Board of Selectmen Meeting
Wednesday, June 22, 2016

Dog Park Options briefing

RE: Dog Park Update

Feasibility and Budgeting Studies for
Off-Leash Recreation Areas
(Dog Parks)
Winchester, MA

<p>D1</p>	<p>OLRA STUDIES Winchester, MA Scale: 1" = 80' April 15, 2016</p>	<p>LEONARD FIELD OPTIONS</p>	<p>Leonard Design Associates <i>Site Planning/ Landscape Architecture</i> p (781) 641-0750 f (781) 646-3174 aleonard@leonarddesign.info</p>
------------------	--	---	---

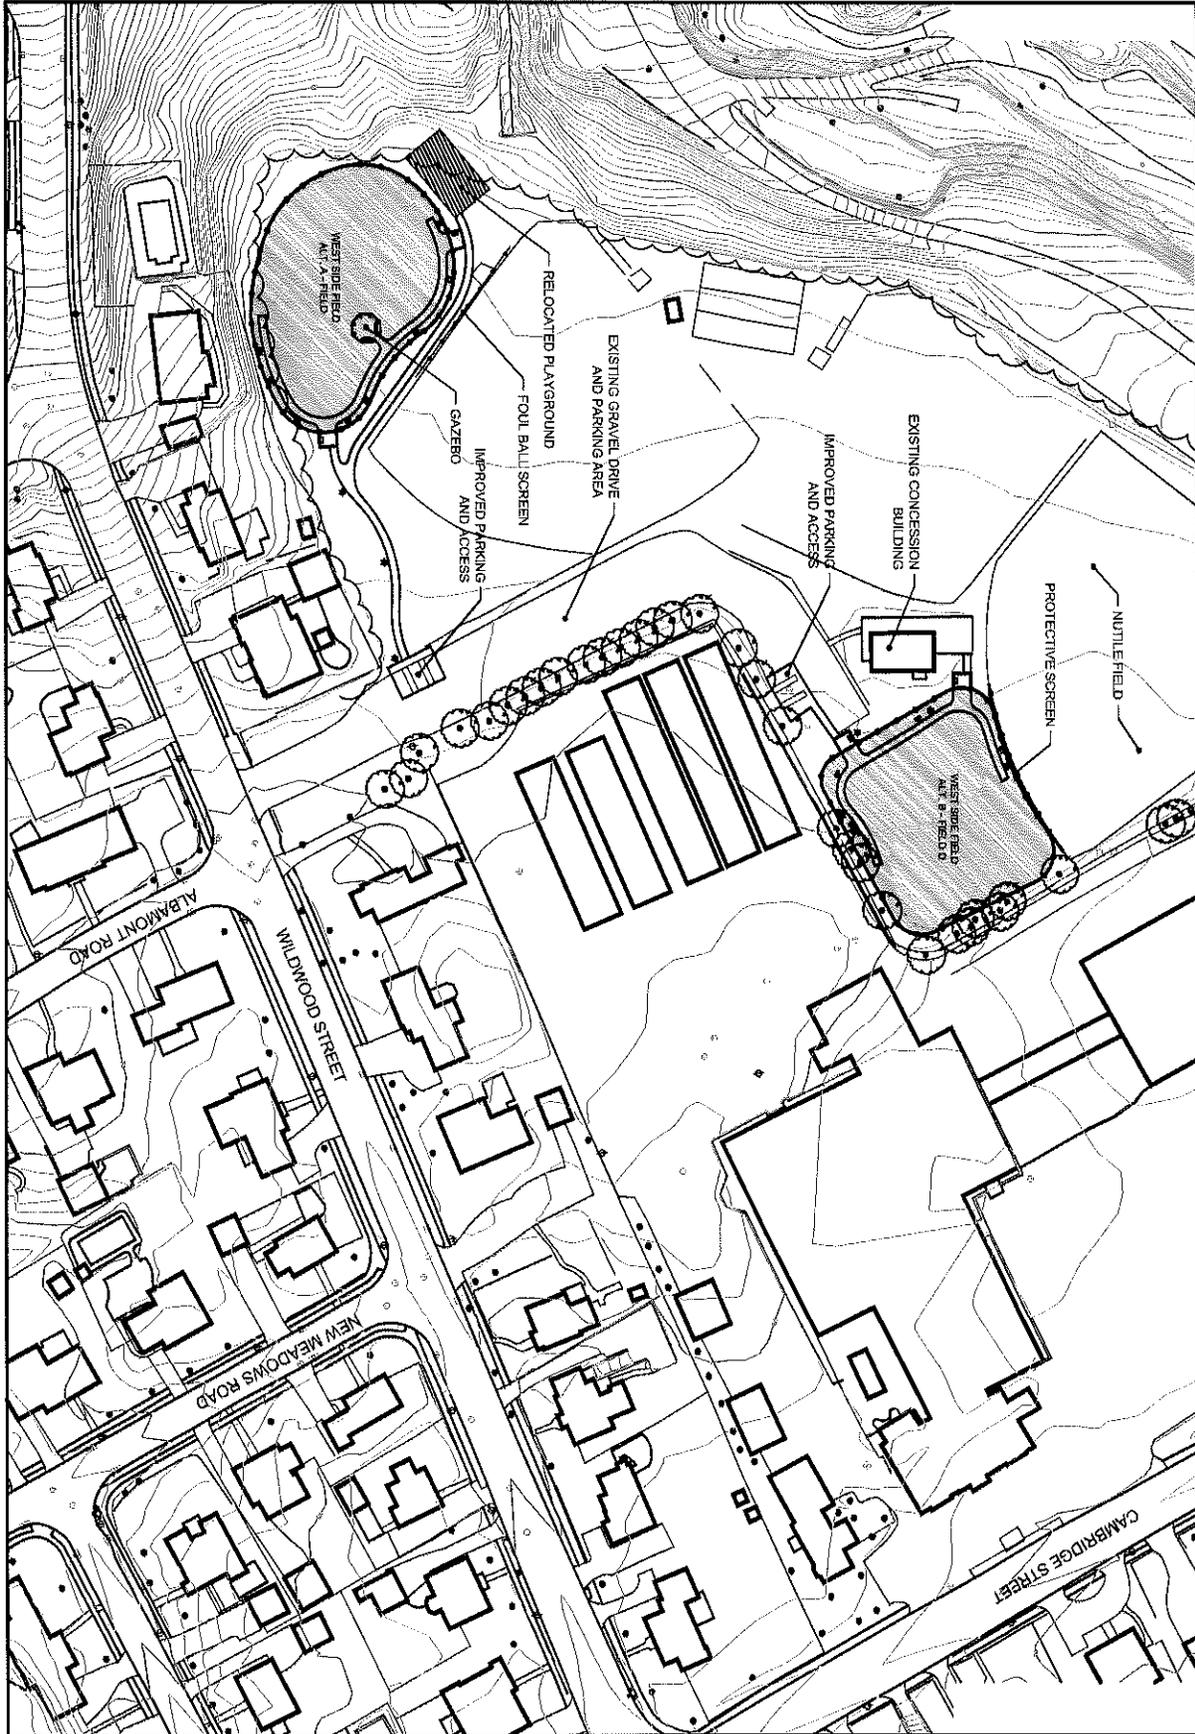
- 1.) That the dog park should be located away from a water body, as dog waste runoff would could pollute it; (Eliot Park and Leonard's Field)
- 2.) That the Commission would object to the removal of a forest, or part of a forest, to create the park; (Lynch Woods)
- 3.) That the location off Rt. 28 in the Middlesex Fells may be adequate and already exists;
- 4.) The proposal may warrant an Article 97 (changed use of public space or park) review – please see Wade;
- 5.) Any park within 100 feet of a waterbody or within 200 feet of Horn Pond Brook or the Aberjona River will require a permit from the Commission.

- Both of the Leonard Field/Beach options are located in close proximity to Leonard Pond and the Aberjona River, with Alternative A being located directly between the two bodies of water. The Engineering Department is concerned about the potential for bacterial contamination of these two waterbodies resulting from the Dog Park. The MS4 permit recently issued by USEPA will require the Town to identify and eliminate potential sources of bacteria within the Aberjona River watershed. While we understand that owners will be primarily responsible for picking-up after their pets at the facility, it seems best if we can relocate the park further away from any waterbodies to prevent this from becoming a potential source of pollution.

- The proposed parking area and driveway for the Leonard Field/Beach options conflicts with the proposed location of the Tri-Community Bikeway, which will follow the route of the existing path from Cross Street, around Leonard Pond, and towards the Muraco School. If this option is selected for further consideration, the Town will need to coordinate with MassDOT to determine whether construction of this parking area and driveway would be allowed within the limits of the bikeway project.

<p>D2</p>	<p>OLRA STUDIES Winchester, MA Scale: 1" = 80' April 15, 2016</p>	<p>WEST SIDE FIELD OPTIONS</p>	<p>Leonard Design Associates <i>Site Planning/ Landscape Architecture</i> p (781) 641-0750 j (781) 646-3174 aleonard@leonarddesign.info</p>
------------------	--	---	---

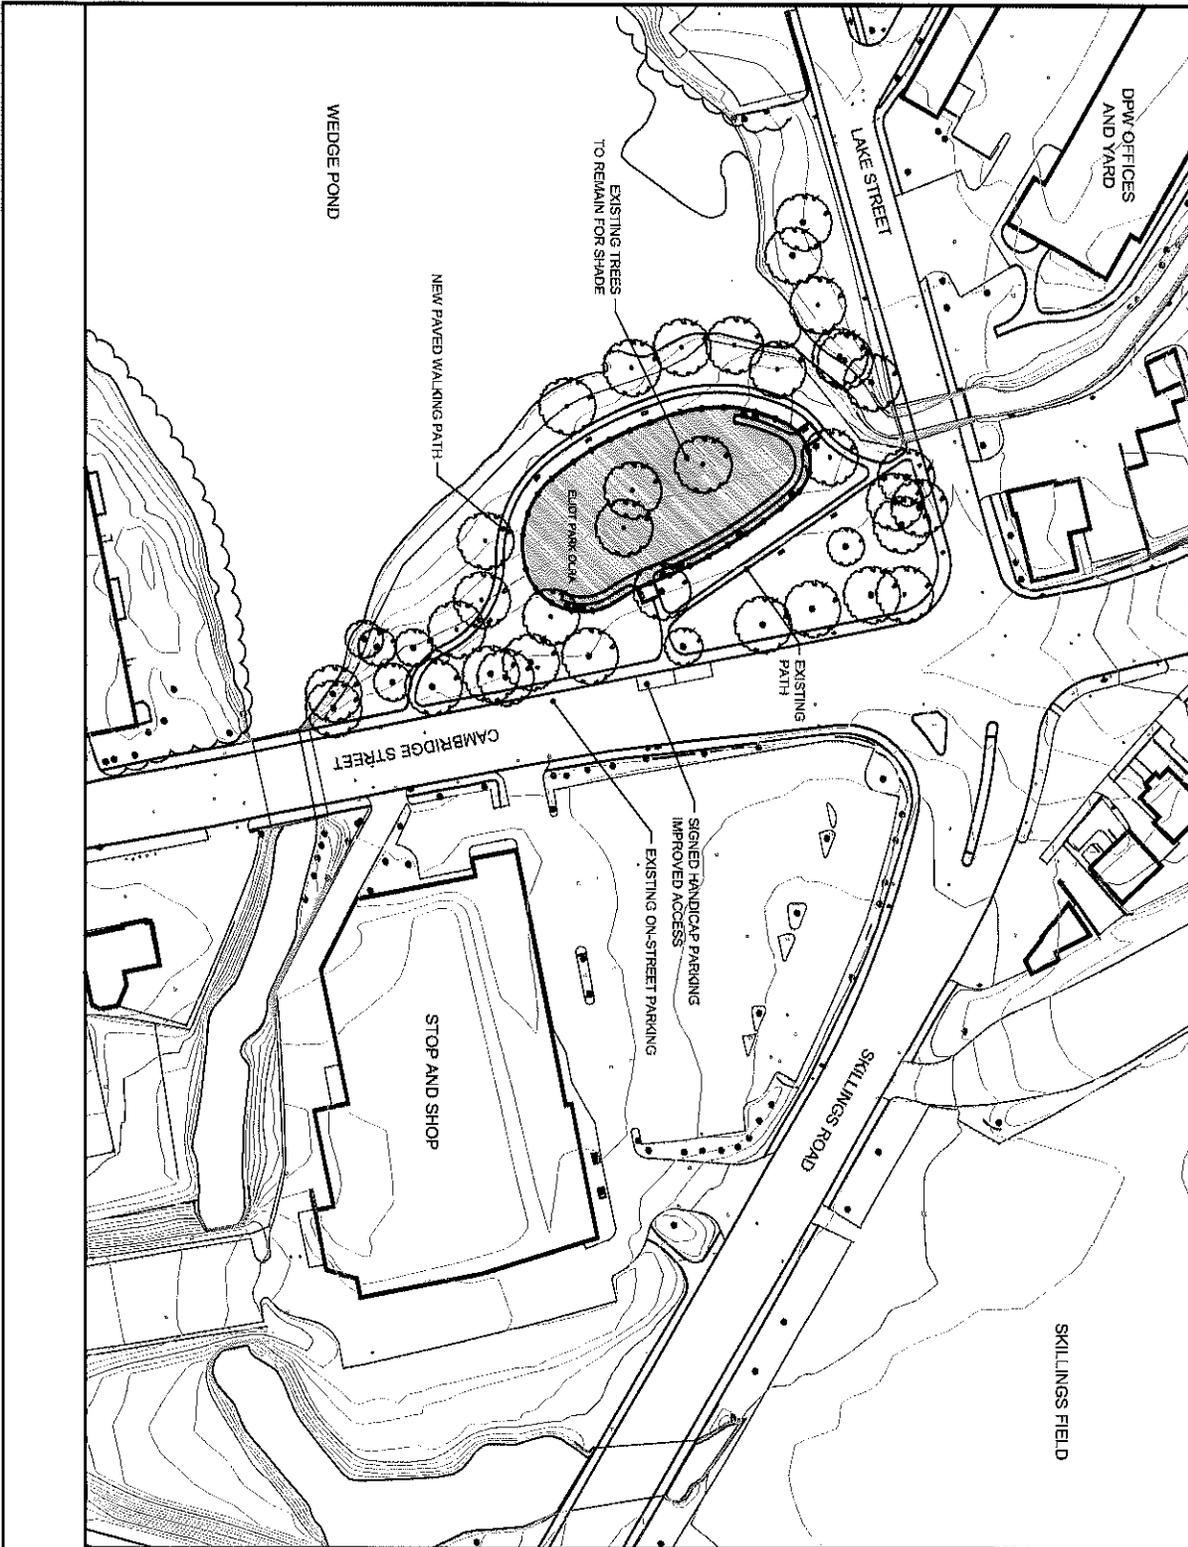
- From our preliminary review of this material, it appears that the West Side Field alternatives would have the least impact to water quality and traffic of all the sites studied, with the location for Alternative B being slightly preferred given its further distance from the existing stream and headwall on the west side of the field. The primary concern regarding traffic and parking is the combined use of site during the peak of baseball/softball season when the existing parking lot would likely not be sufficient to cover both uses.
